Wisconsin Department of Transportation

Proposal #01: 3080-01-40
Madison - Cambridge
CTH AB Overpass
USH 12
Dane County

This is Addendum No. 02, which provides for the following:

ADDENDUM NO. 02
3080-01-40/3080-01-75/3080-01-76
July 05, 2022

Addendum No. 02
ID 3080-01-76
Revised Sheet 32
July 5, 2022

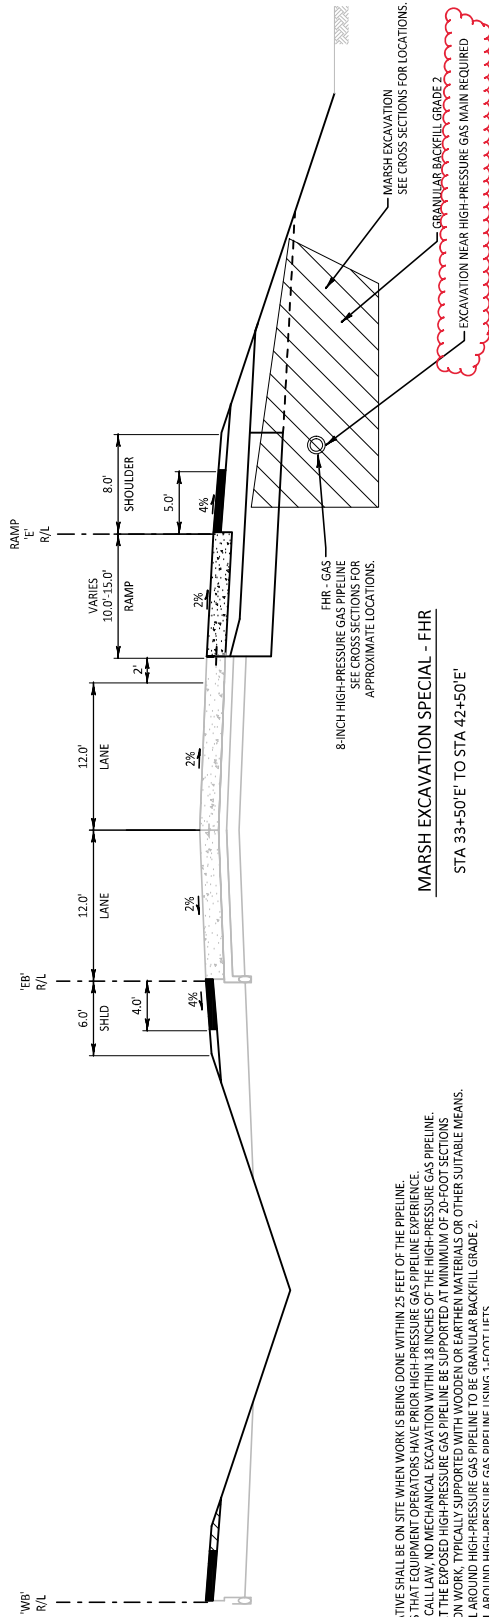
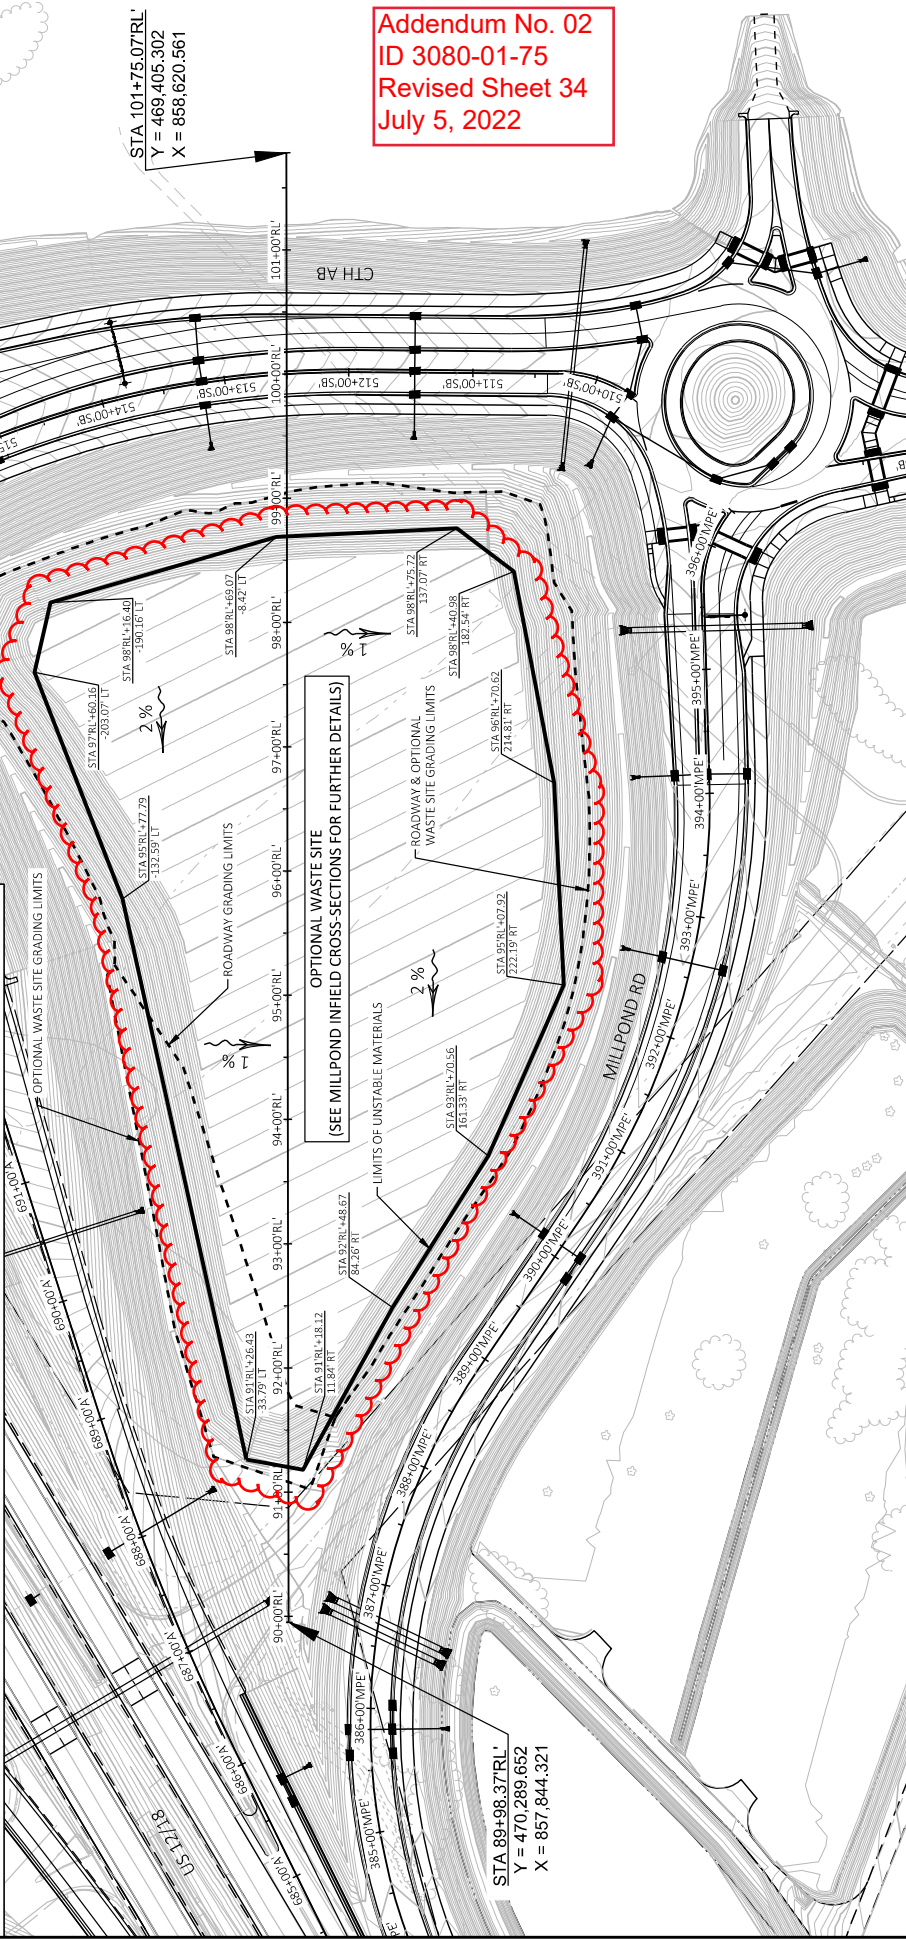
Revised Plan Sheets	
Plan Sheet	Plan Sheet Title (brief description of changes to sheet)
32	Construction Detail-Marsh Excavation Special - FHR (added note for excavation near high-pressure gas main)
34	Construction Detail-Millpond Infield-Optional Waste Site (added limits of unstable materials)
492	Miscellaneous Quantities (added table for Excavation Near High-Pressure Gas Main)

MARSH EXCAVATION SPECIAL - FHR

- CONSTRUCTION NOTES:
1. A FHR REPRESENTATIVE SHALL BE ON SITE WHEN WORK IS BEING DONE WITHIN 25 FEET OF THE PIPELINE.
 2. FHR RECOMMENDS THAT EQUIPMENT OPERATORS HAVE PRIOR HIGH-PRESSURE GAS PIPELINE EXPERIENCE.
 3. PER WI STATE ONE CALL LAW, NO MECHANICAL EXCAVATION WITHIN 18 INCHES OF THE HIGH-PRESSURE GAS PIPELINE.
 4. FHR REQUIRES THAT THE EXPOSED HIGH-PRESSURE GAS PIPELINE BE SUPPORTED AT MINIMUM OF 20-FOOT SECTIONS.
 5. BURIED EXCAVATION WORK SHALL BE CONDUCTED WITHIN THE EXISTING OR EXISTING WATERWAYS OR OTHER SUITABLE MEANS.
 6. BACKFILL MATERIAL AROUND HIGH-PRESSURE GAS PIPELINE SHALL BE GRANULAR BACKFILL GRADE 2.
 7. COMPACT BACKFILL AROUND HIGH-PRESSURE GAS PIPELINE USING 1-FOOT LIFTS.
